Office Action Summary

10/706,392

MARUYAMA, KUNIYA

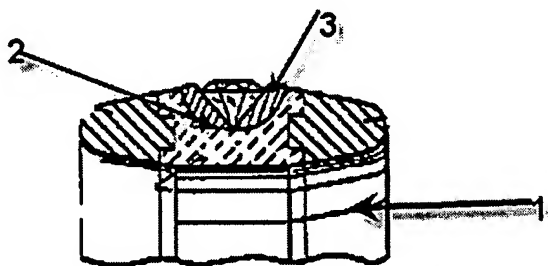
As for Claim 1, West teaches of an item of jewelry (see figure below) comprising a main body (1) having an inlay area of concaved shape (2), and a decorating part (3) secured in said inlay area (2), the improvement comprising said decorating part (3), said decorating part (3) being composed of precious metal components (col. 6, lines 28, and from Claim 1, “a precious metal disposed within said groove”), said decorating part (3) being secured in said inlay area (2) by a layer of solder (col. 6, line 30, “One way to affix precious metal to the part is to use a brazing process...”) in said inlay area (2) between said decorative part (3) and said main body (1).

The difference between the claim and West is that West does not expressly state that the composition of the decorative part (3) secured in the inlay area (2) of the main body (1)

Re: Claim 2, wherein said jewelry has a curved surface at said inlay area (2).

As for Claim 8, West teaches of an item of jewelry (see figure above) comprising a main body (1) having an inlay area (2) of concaved shape and a decorating part (3) secured in said inlay area (2); said inlay area (2) comprising a main channel (1/2) and at least one groove extending from a side of said channel (1/2); said decorating part (3) being composed of a copper alloy which contains 6 to 15 percent copper and 94 to 85 percent gold (see above statement from claim 1); said decorative part (3) being secured in said inlay area (2) said decorating part (3) corresponding in shape to the shape of the inlay area (2) main channel (1/2); said decorating part (3) being deformable to fill said at least one groove upon the application of pressure to said decorating part (3).
